Our Ref: 1305/2022.08.12/LLFA/JB

12th August 2022

**Response to comments from Lead Local Flood Authority to application No. App
Ref:20220432**

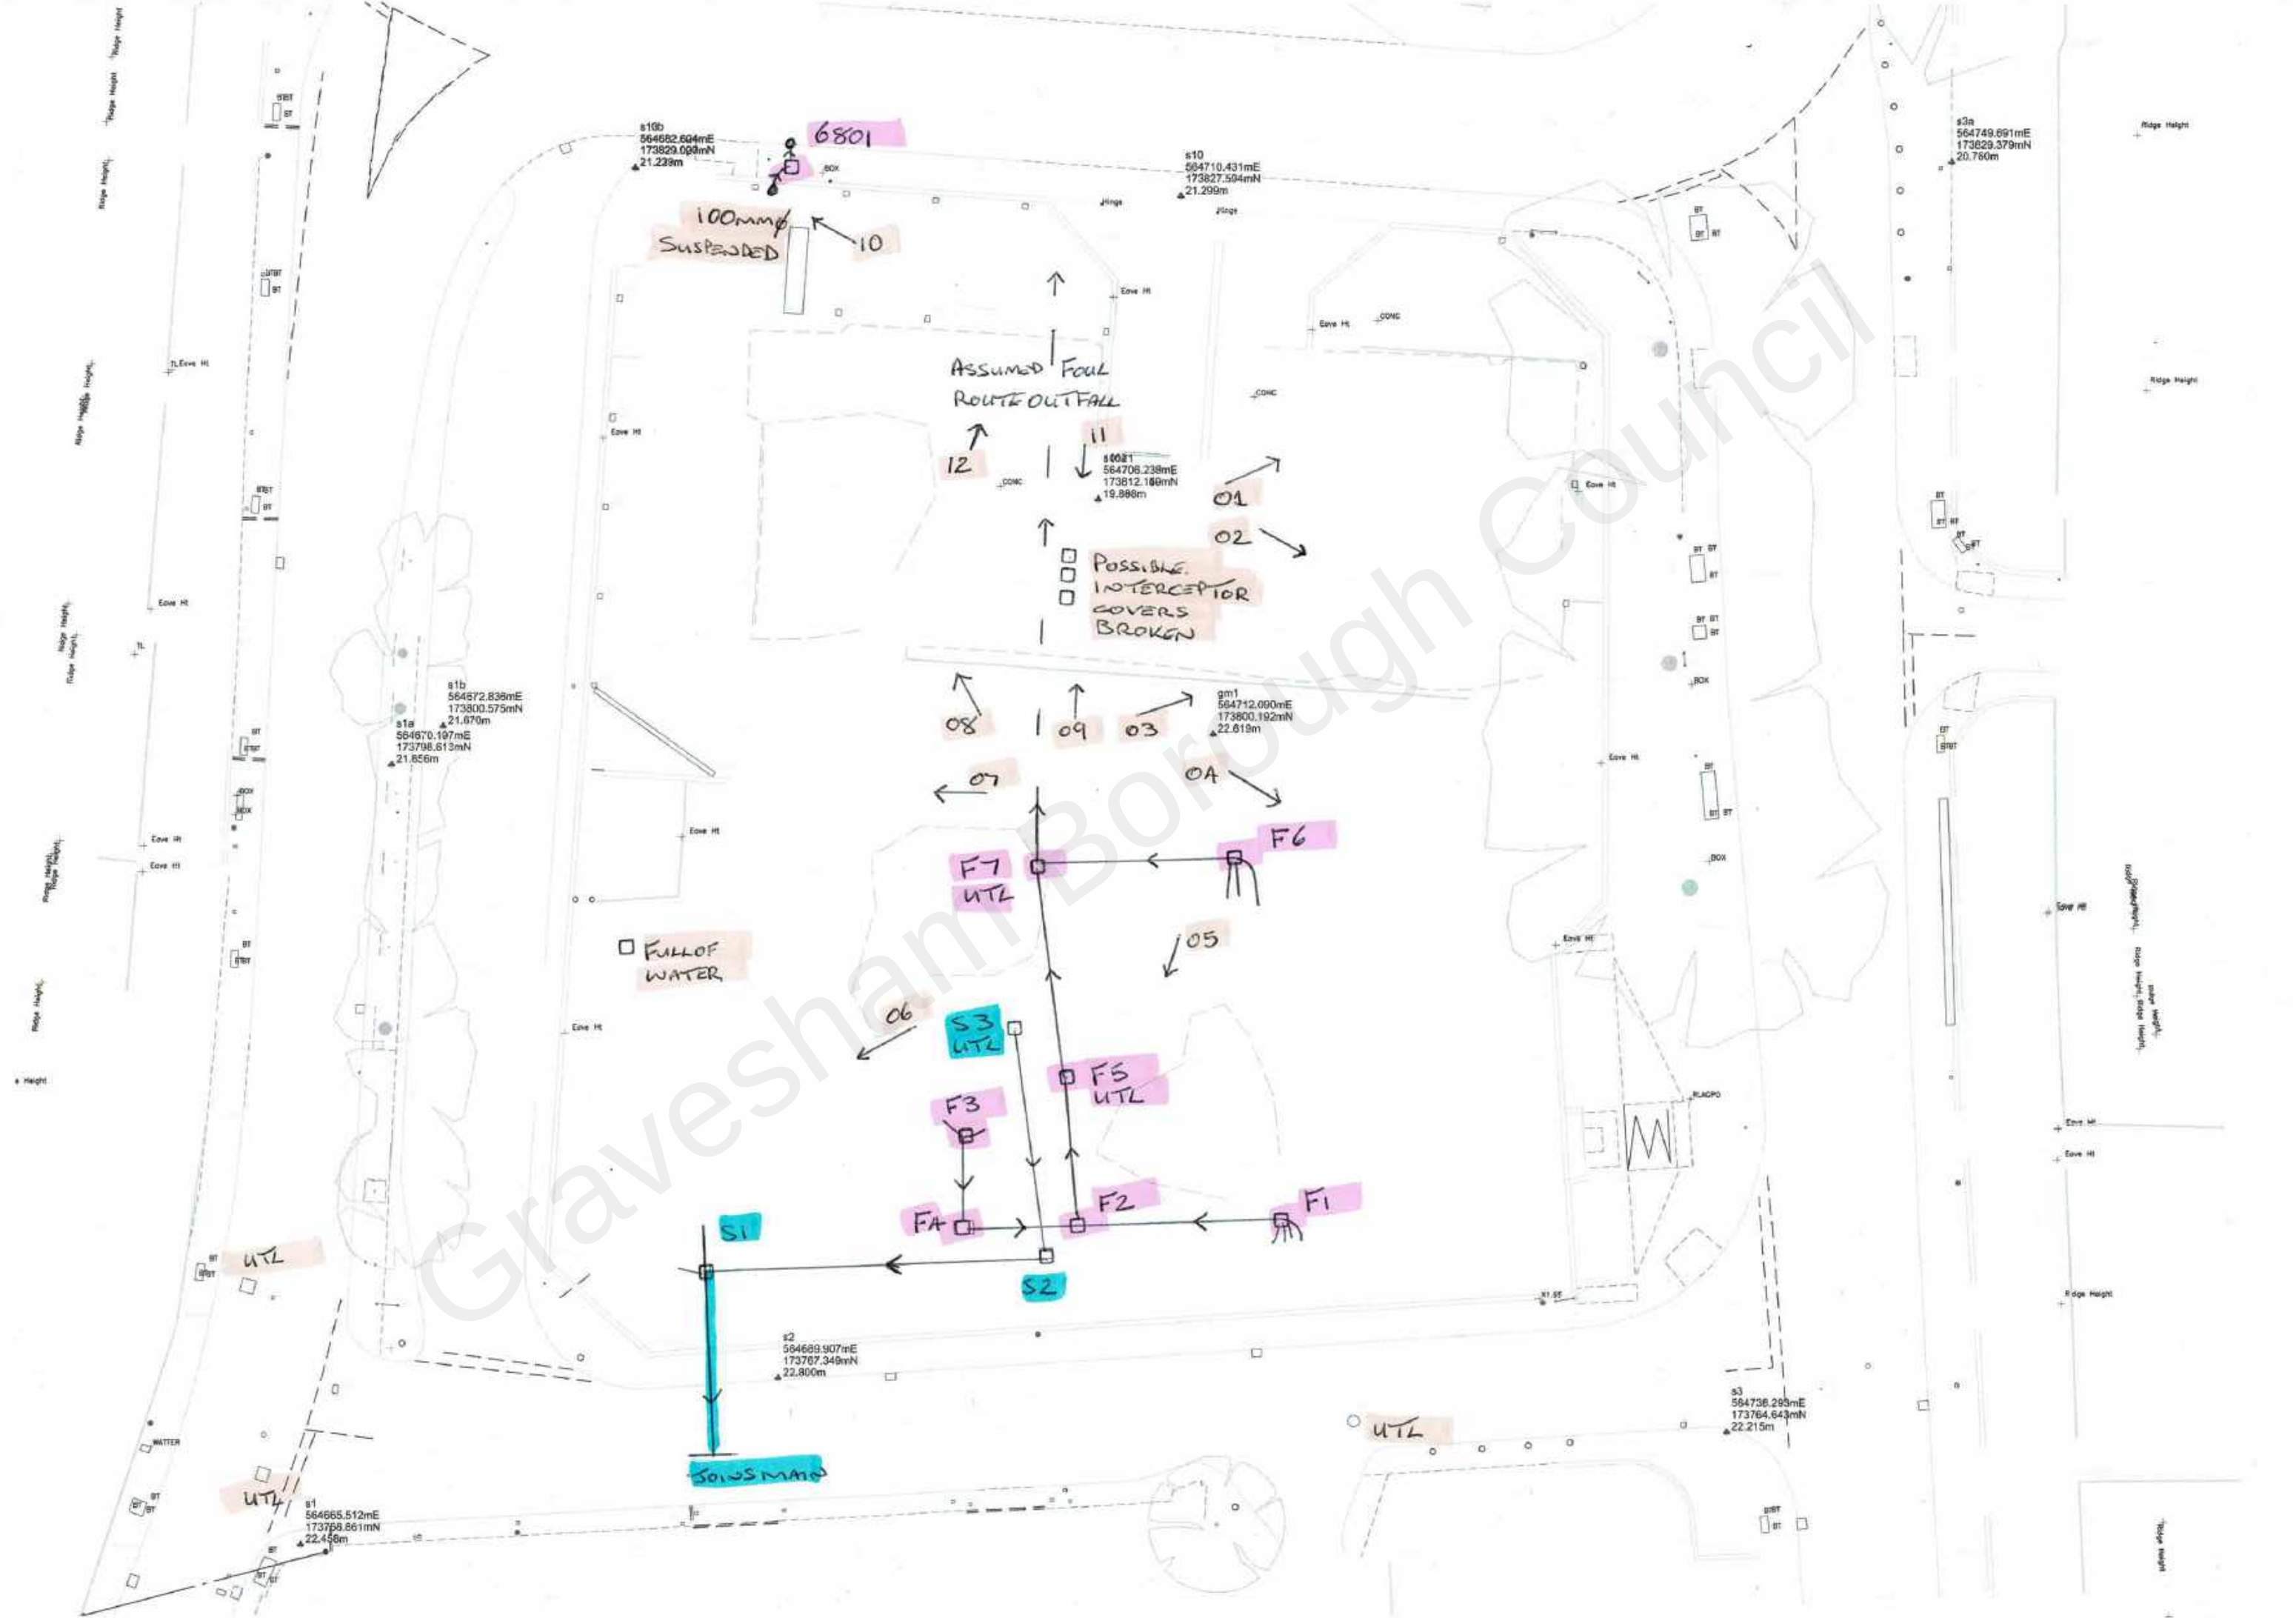
During the pre-development connection enquiry Southern Water asked us to substantiate any surface water connection of the site to the adopted surface water sewer. We have undertaken a CCTV survey of on-site drainage and identified an

existing surface water connection to the off-site adopted drainage network (see enclosures). We have undertaken an estimation of the roof area of the previously demolished building and the area of impermeable hardstanding that could be connected to the existing drainage connection by the current extant planning application. The extant planning application would allow for connection of an area in excess of the previously connected roof area. Therefore, we have conservatively assessed the existing discharge from the site based on the circa 1000m² area of previously connected roof. In assessing the existing discharge rate we have limited discharge from the site to those based on the peak discharge supported by the 150mm sewer that leaves the site, assumed to be laid at a gradient that meets self-cleansing velocity requirements for surface water systems, 17.75l/s. If the 150mm discharge pipe was laid at 1in150, the peak discharge would be 14.46l/s.
